RESPONSIVENESS SUMMARY
FOR
SUBURBAN WATER SYSTEMS

BARTOLO WELL FIELD
OPERABLE UNIT FEASIBILITY STUDY
SAN GABRIEL AREAS 1, 2, AND 4
LOS ANGELES COUNTY, CALIFORNIA

FIGURE 1
AREAS RECEIVING HAND-DELIVERED
PUBLIC MEETING NOTICE

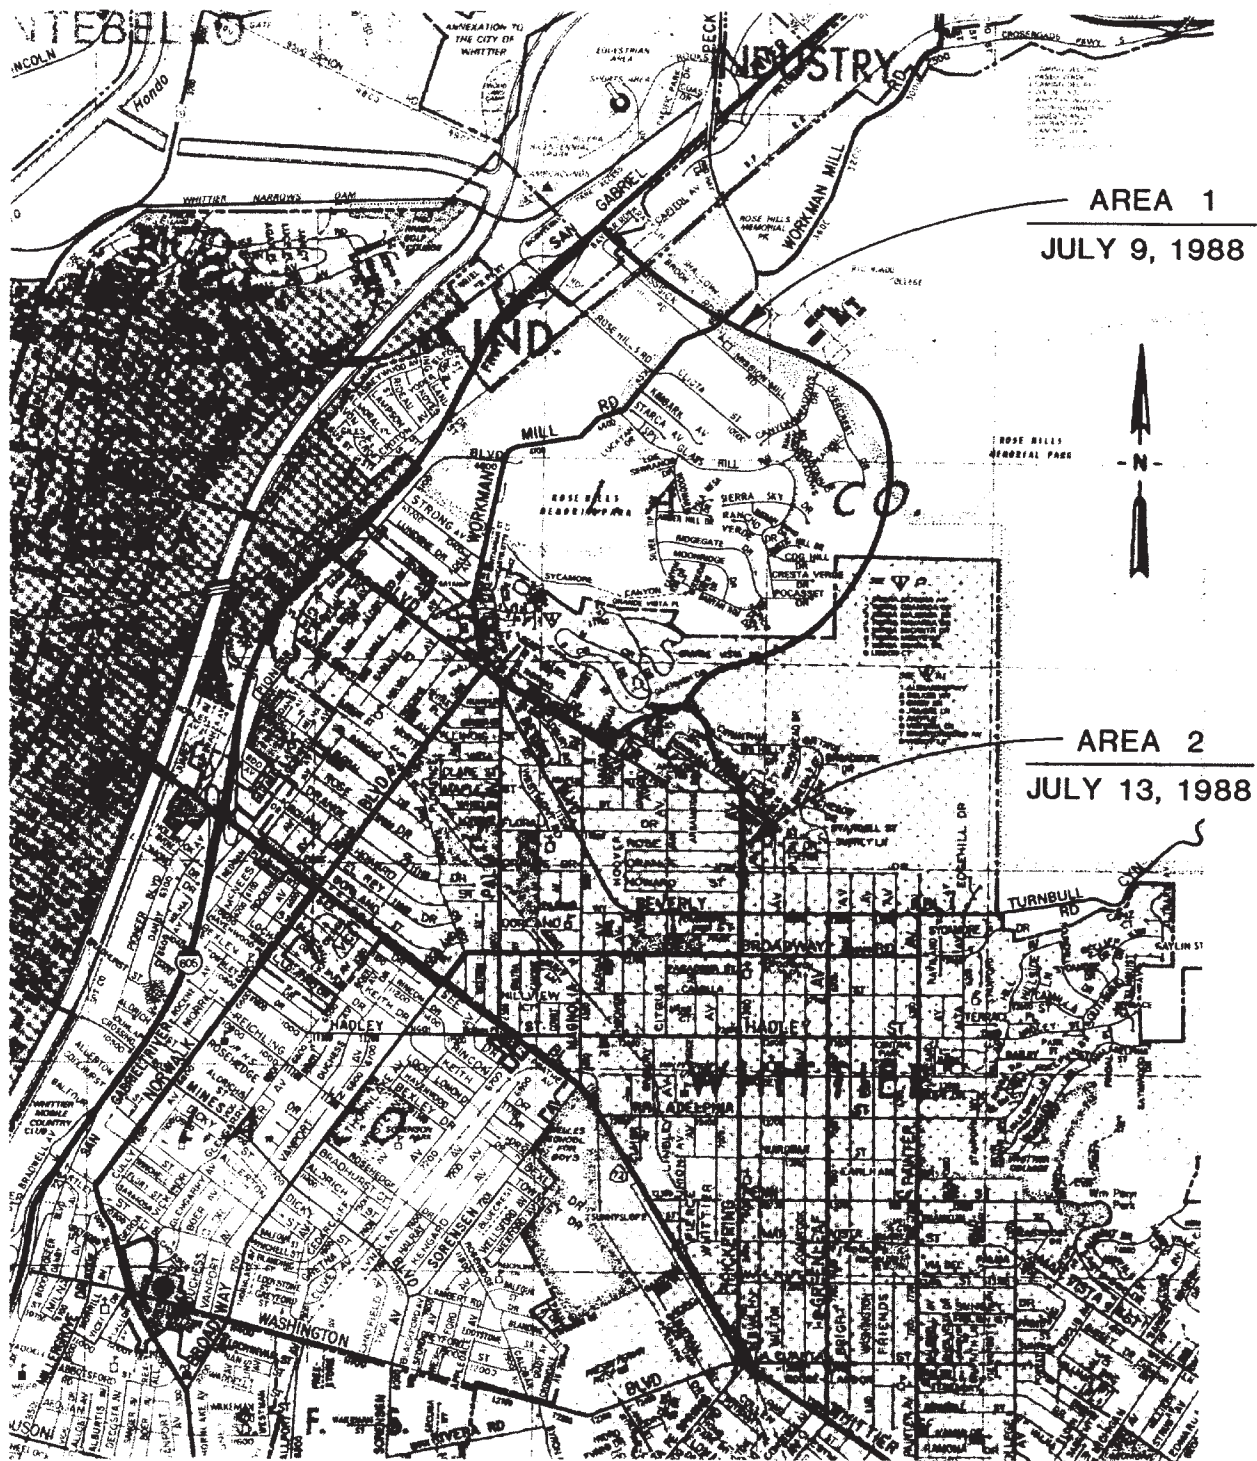
2. One resident requested a more detailed map and explanation of the broken line shown on the map provided in the public meeting notice delivered door-to-door.

EPA Response: The broken line is the approximate route of the Bartolo Transmission Main that transports water from Suburban's Bartolo Well Field to its customers in the Whittier District. Additional detail on the route is shown in Figure 2-4 of the OUFS. Exact routing can be obtained from Suburban Water Systems.
